Calvert Cliffs Nuclear Power Plant
1650 Calvert Cliffs Parkway
Lusby, Maryland 20657
410 495-4455

SUBJECT: Calvert Cliffs Nuclear Power Plant
Unit Nos. 1; Docket Nos. 50-317
License Amendment Request: Revision to Technical Specification P-T Curves

TECHNICAL SPECIFICATION MARKED-UP PAGES

Figure 3.4.3-1
Calvert Cliffs Unit 1 Heatup Curve, for Fluence $\leq 2.61 \times 10^{19}$ n/cm²
Reactor Coolant System Pressure Temperature Limits

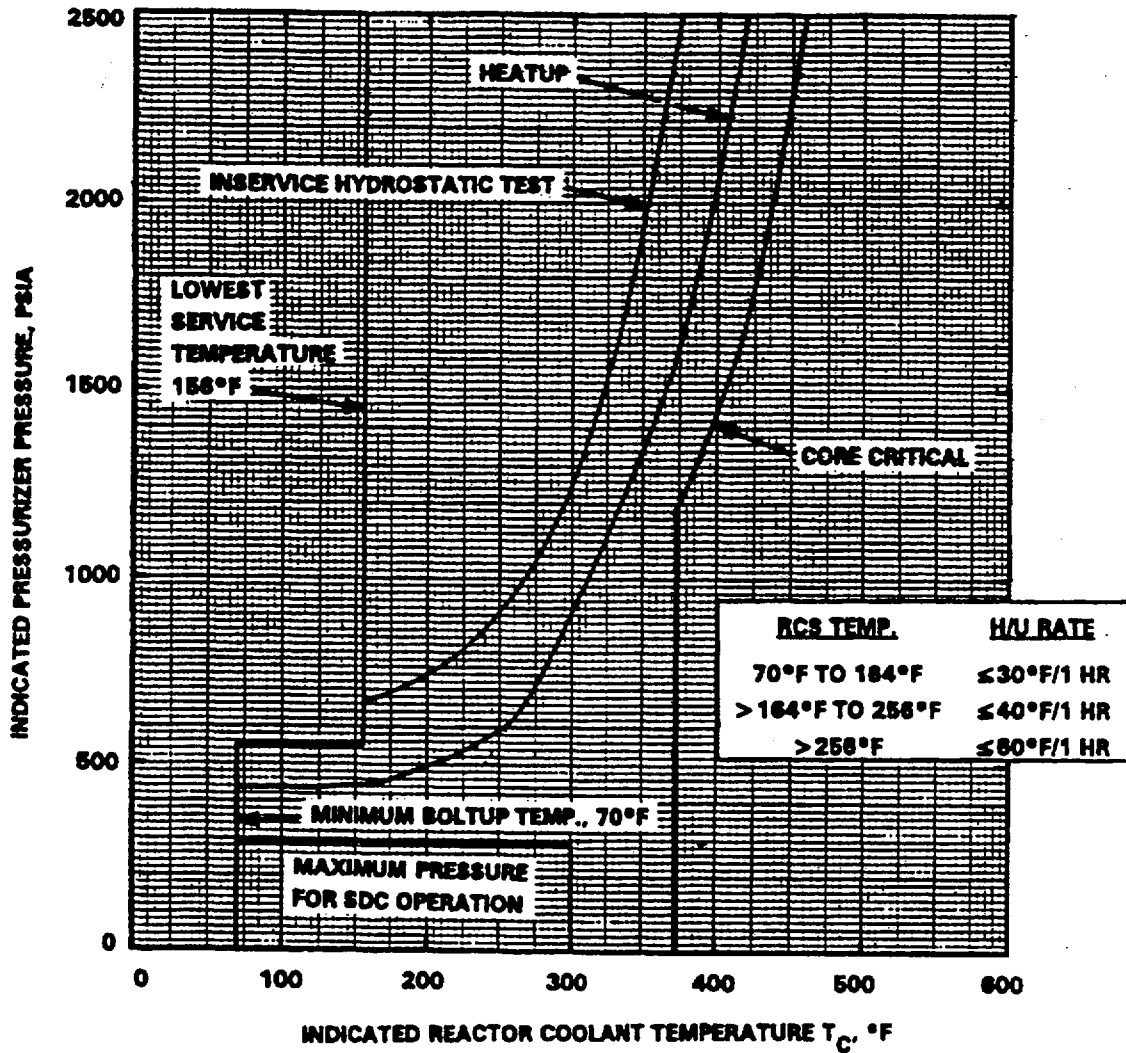
The proposed amendment revises the Unit 1 Heatup Curve (Technical Specification Figure 3.4.3-1), Unit 1 Cooldown Curve (Technical Specification Figure 3.4.3-2), and Unit 1 Maximum Power-Operated Relief Valve (PORV) Opening Pressure vs Temperature Curve (Technical Specification Figure 3.4.12-1) to change fluence level from 2.61×10^{19} n/cm² to 4.49×10^{19} n/cm² (E>1MeV). This change reflects the new actual fluence level for which these curves are valid, and is necessary to extend the applicability of the curves for Unit 1 operation.

Revise Unit 1 Technical Specification Figures 3.4.3-1, 3.4.3-2, and 3.4.12-1 as shown in the marked-up Technical Specification pages in Attachment (1).

4.49

Figure 3.4.3-2
Calvert Cliffs Unit 1 Cooldown Curve, for Fluence $\leq 2.61 \times 10^{19}$ n/cm²
Reactor Coolant System Pressure Temperature Limits

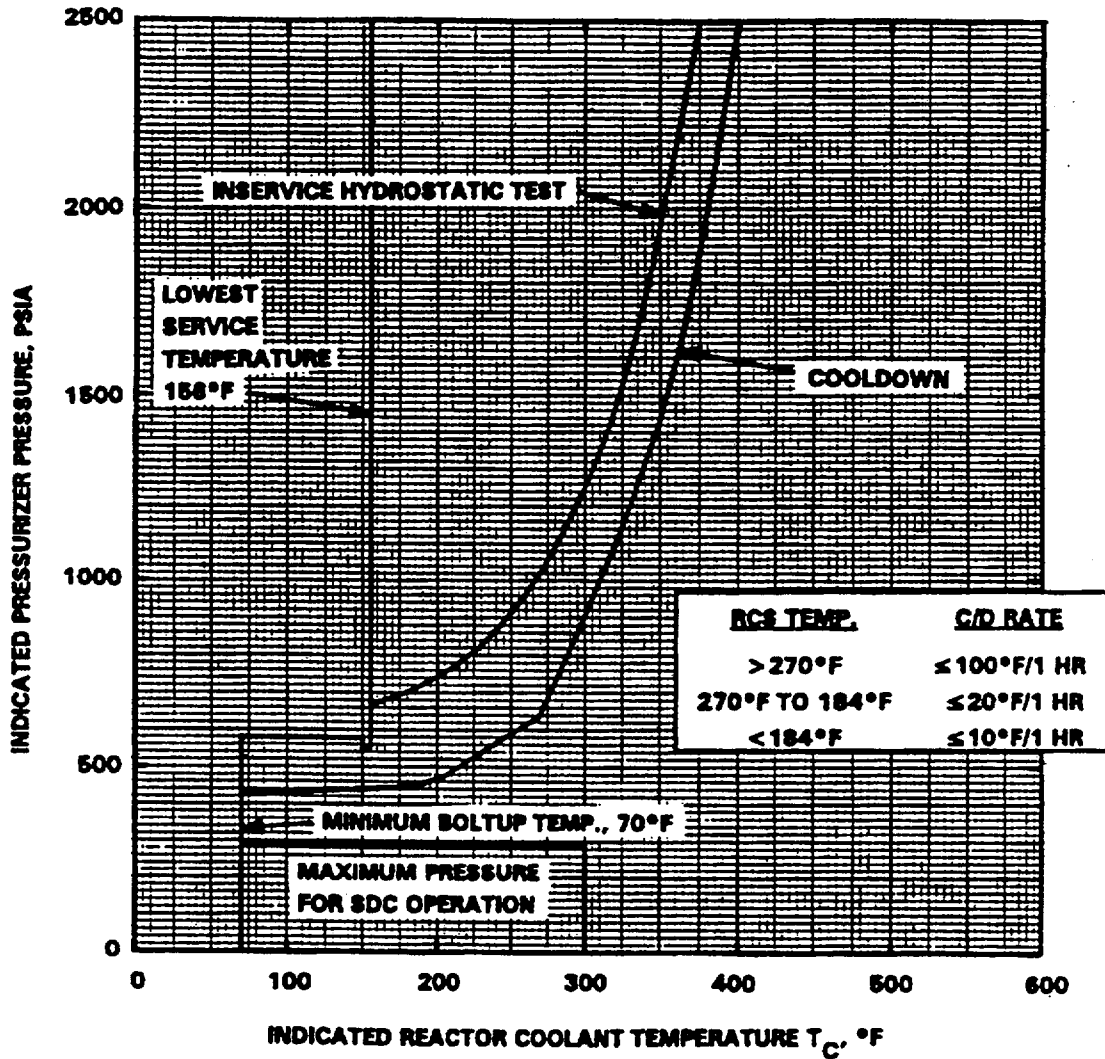
4.49
